X3T9.2/92-11

To: X3T9.2 COMMITTEE (CAM)
From: Chris Runowicz, Hewlett-Packard Company
Subject: DMA data transfer method as outlined in AT Attachment
Date: 12/30/91

Operation:

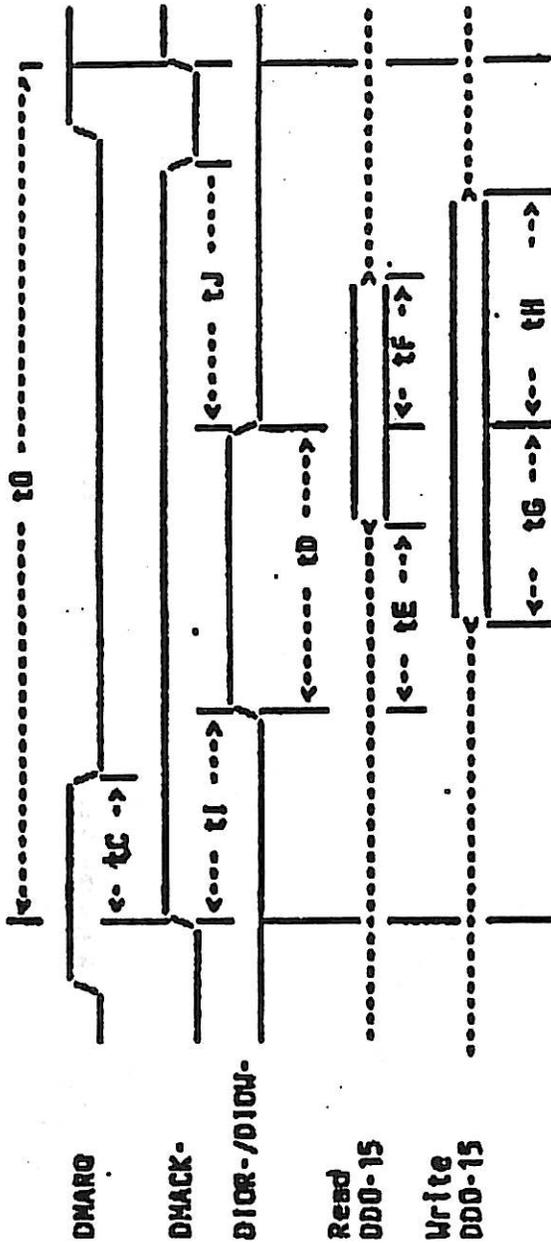
- phase 1: To begin a DMA data transfer cycle, the drive asserts DRQ when data is ready to be transferred. DRQ is held asserted until the entire specified data transfer is completed, or the drive must abort the data transfer flow, for example to refill/flush its data FIFO.

- phase 2: The system asserts ~DACK when the drive's DMA channel has won arbitration. ~DACK is held asserted until the entire specified data transfer is completed, or the system must abort the data transfer flow, for example to refill/flush its data FIFO. If ~DACK is negated to abort the specified data transfer, the drive can either negate or hold DRQ asserted (anticipating the next cycle). Either way, the DMA transfer cycle is completed. It is recommended that the drive not negate DRQ, as this will save time by immediately beginning the next cycle once the system is ready.

- phase 3: While maintaining DRQ and ~DACK asserted, a minimum of one IO Read or IO Write will be asserted. The trailing edge of each IO Read or IO Write shall latch 16-bits of data. Depending on the type of operation, IO Read or IO Write pulses can sequentially come from the system within a minimum of 4 backplanes clock periods (i.e. 8MHz backplane, minimum IOR/W cycle time is 500ns), each transferring 16-bits of data. IO Reads and IO Write pulses will not be mixed together in the same DMA data transfer cycle, and will be determined by type of drive command presently executing, either Read DMA or Write DMA.

- phase 4: The DMA data transfer cycle will end when either the drive or system determines the full completion of the specified data transfer, or if the data transfer must be aborted. To end or abort the data transfer, the drive shall negate DRQ after the leading edge of the assertion of the last valid IO Read or IO Write. To end or abort the data transfer, the system shall negate ~DACK after the trailing edge of the assertion of the last valid IO Read or IO Write. At this point the DMA data transfer cycle is completed.

"CORETEST" TRANSFER RATES when installed in an EISA system

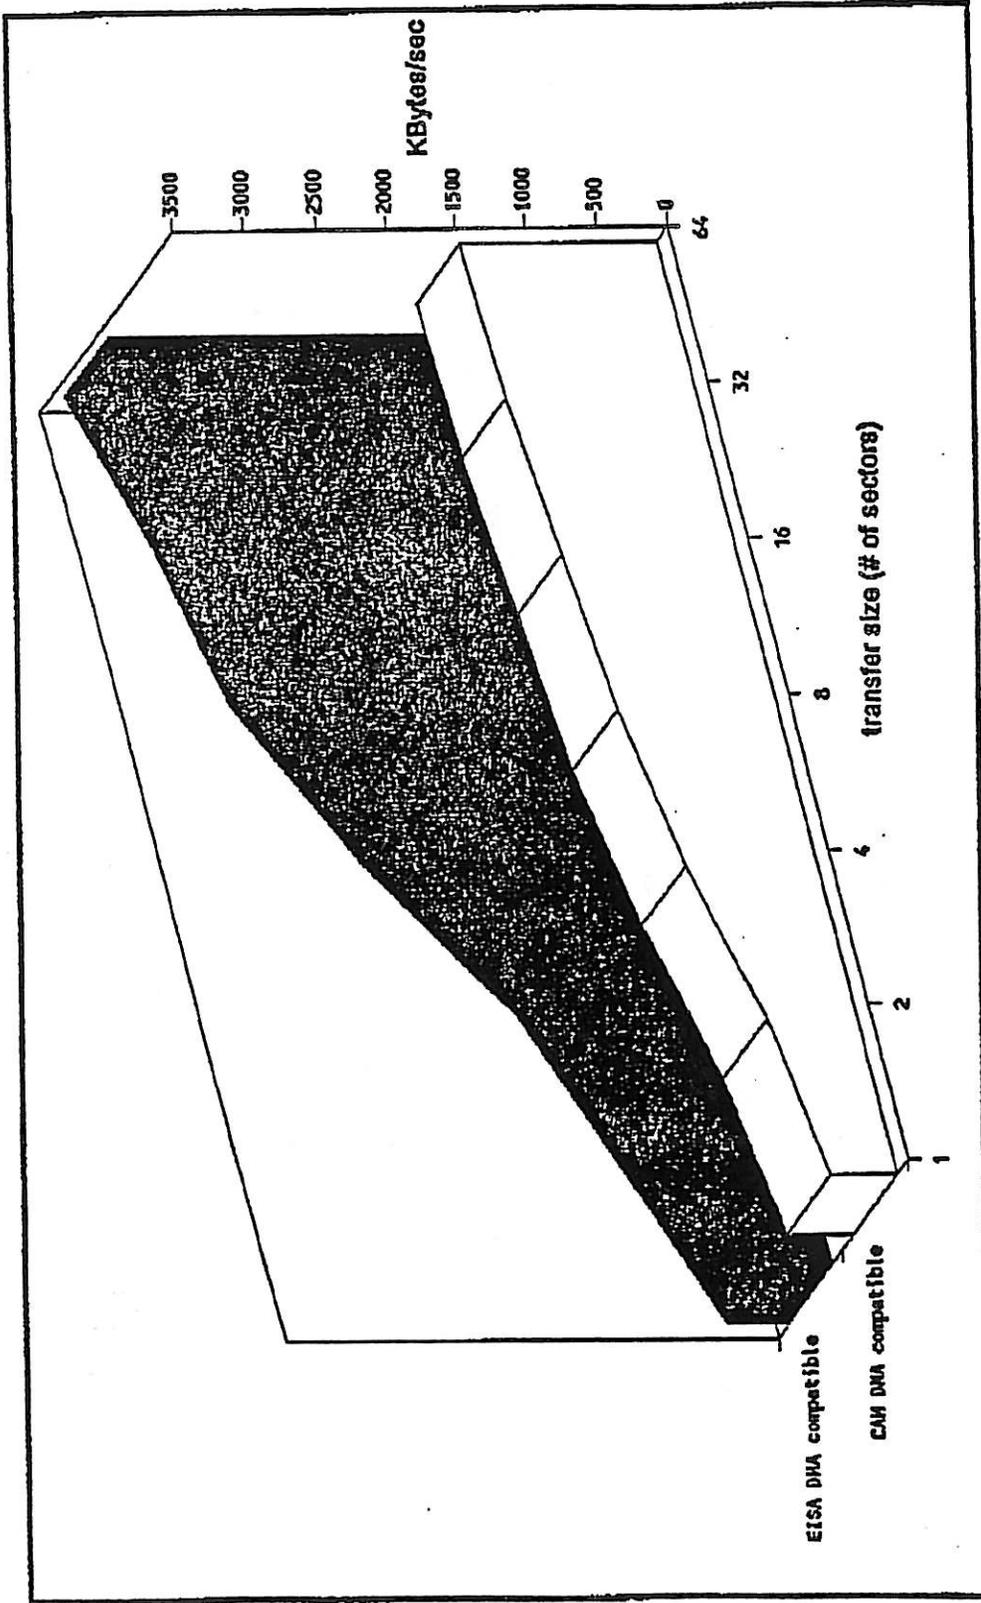
The CAM AT Attachment specifies that only word of data will be transferred per DMA data transfer cycle. This is illustrated in Figure 11-3 of the document. With this, system arbitration overhead penalties are disastrous. However with the EISA DMA B-type Demand Mode protocol, more than one word of data can be transferred per DMA data transfer cycle. Hence, the arbitration overhead can be amortized over more data transfers, thereby approaching the 4Mbyte/s limit (see the attached performance comparison chart). It is proposed that CAM specifies this transfer process.

(EXISTING)
 #SADNE TIMING for CAN DMA timing v1.1

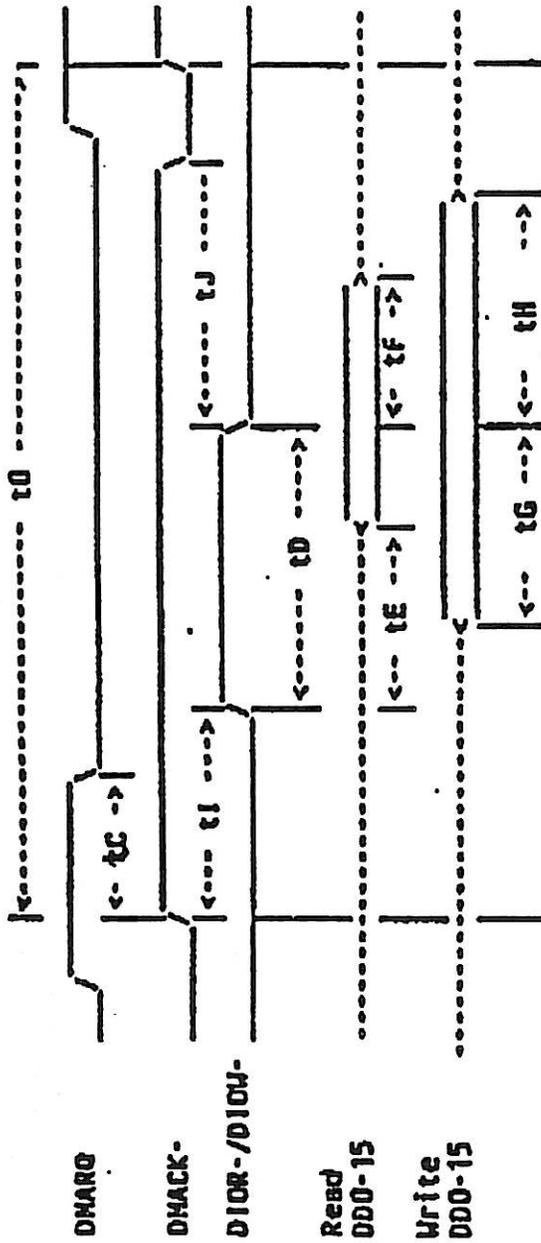
There are 3 modes of DMA operation presently specified by the CAM AT-Attachment: modes 0, 1 and 2. Mode 0 is compatible with ISA DMA data transfers and should remain unchanged. Modes 1 and 2 are not compatible or functionally appropriate (see performance comparison) with either ISA DMA or EISA B DMA Demand mode. Hence, it is proposed that the operation and specification of mode 1 and mode 2 change to reflect the functionality specified above, and timing specified in the following page.

Keep
 Change to mode 1 EISA B
 Change to mode 2 EISA B
